**NEEDS FOR AND ALTERNATIVES TO (NFAT)
REVIEW OF MANITOBA HYDRO'S
PREFERRED DEVELOPMENT PLAN (PDP)**

**REPORT PREPARED FOR
THE MANITOBA METIS FEDERATION**

**BY
WHITFIELD RUSSELL ASSOCIATES**

FEBRUARY 12, 2014

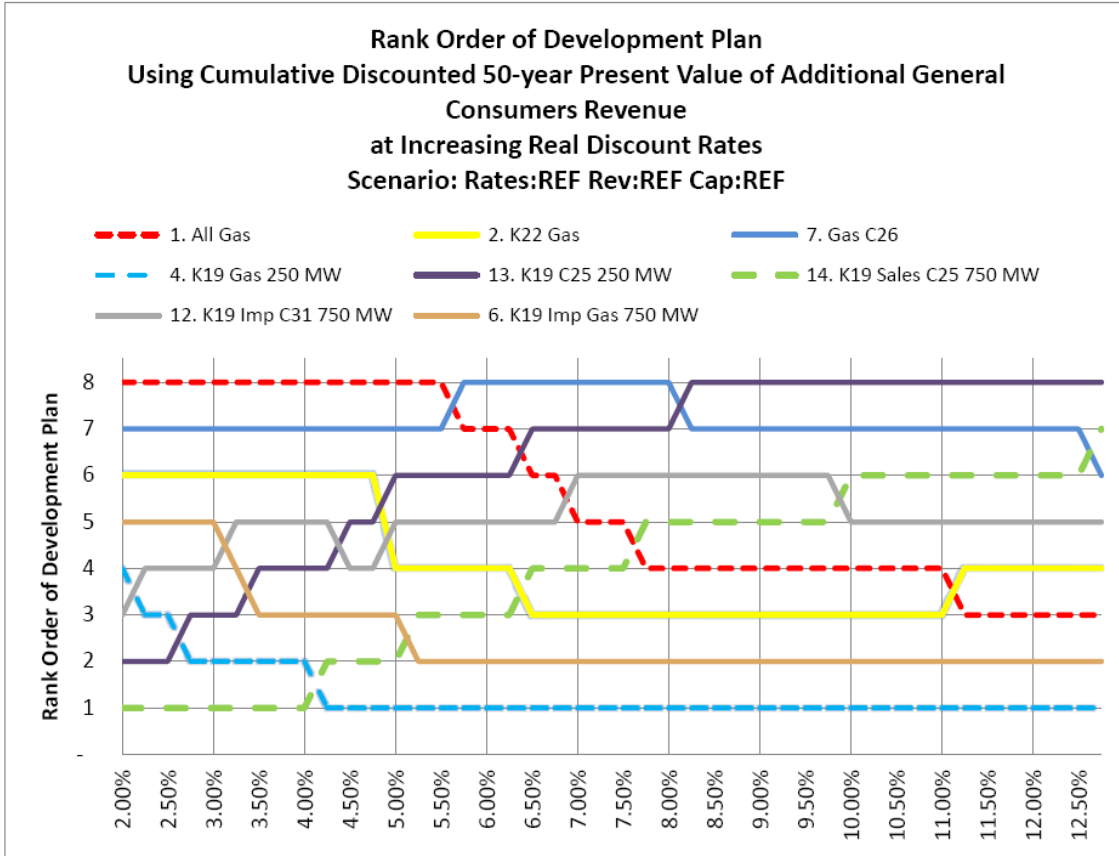
Figure 11.10 shows the impacts on customer rates (seen in Figure 11.1, 1 Chapter 11, page 8) on a present value basis and represents the projected cumulative present value of total general consumers’ revenue for the 50 year study period. Figure 11.10 shows that:

- In the near term, by 2020, the cumulative present values for the various alternatives are relatively similar.
- By 2030, the cumulative present value of the capital-intensive plans that include both Keeyask and Conawapa are generally higher than [those associated with] the other alternatives.
- Between 2030 and 2050, K19/Gas/250 (light blue) is projected to have the lowest cumulative present value at the P50 value.
- From 2050 to the end of the study period, the preferred development plan (green) is projected to have the lowest cumulative present value at the P50 value.

1 **Figure 2.2-1: Load Serving Capability without Bipoles I & II**

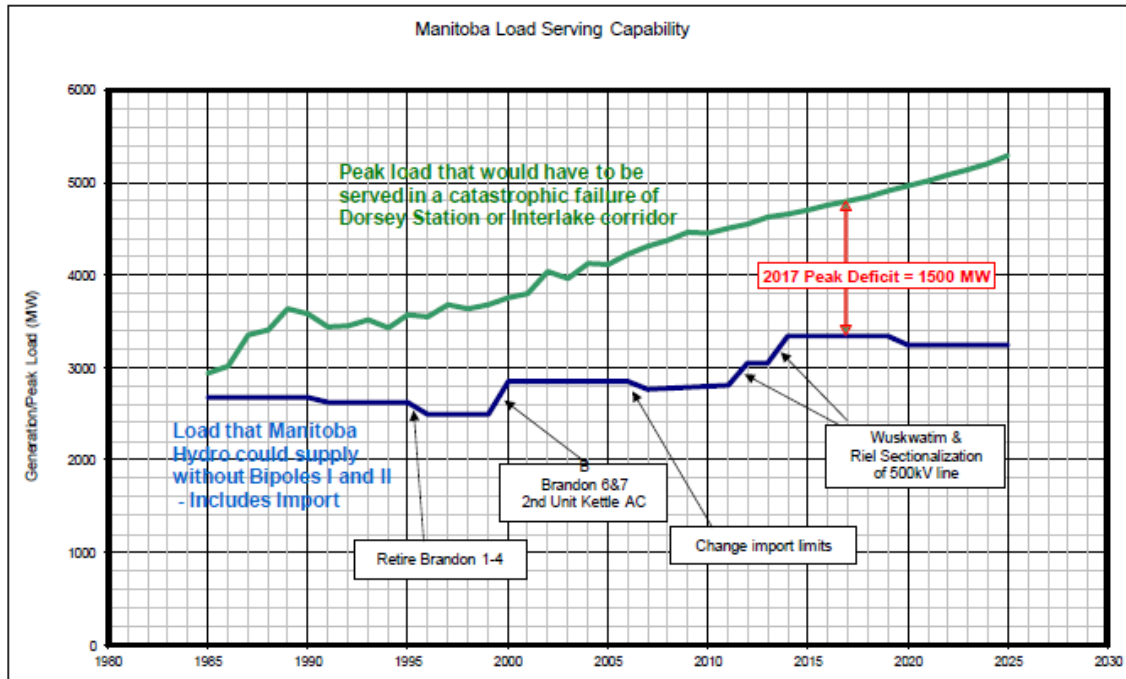
1 Finally, adding Bipole III plus Keeyask and Conawapa would put even more eggs in the
2 Northern Hydro basket which would be vulnerable to a single event taking out all three Bipoles
3 of all Northern Hydro generation (i.e., a "common mode" failure such as tornados or ice build-
4 up) or the loss of Bipoles I and II while Bipole III is out of service for maintenance. Today, the
5 simultaneous or overlapping loss of Bipoles I and II would deprive Manitoba Hydro of 3562
6 MW of Northern hydro generation whereas loss of all three Bipoles would deprive it of 5587
7 MW of Northern Hydro generation once Keeyask and Conawapa are placed in service.
8 Although constructing Bipole III on a right-of-way ("ROW") separate from that used by Bipoles
9 I and II reduces the risk of a common mode failure of all three Bipoles, some of the common
10 mode events could be widespread enough to take out all three Bipoles.

2
3 It appears from Figure 2.2-1 that Manitoba Hydro has been exposed to its alleged susceptibility
4 to loss of Bipoles I and II since 1985 yet it will take more than 30 years to mitigate the impact of
5 such a loss. Manitoba Hydro reports that, at the time of a September 1996 loss of both Bipoles
6 (the only time such a catastrophic loss has occurred in over 35 years), it was able to arrange 985
7 MW of imports to cover the shortfall,³⁰ more than the 700 MW existing firm import limit from
8 the United States and other Provinces. See NFAT Chapter 5 at 16 of 61.
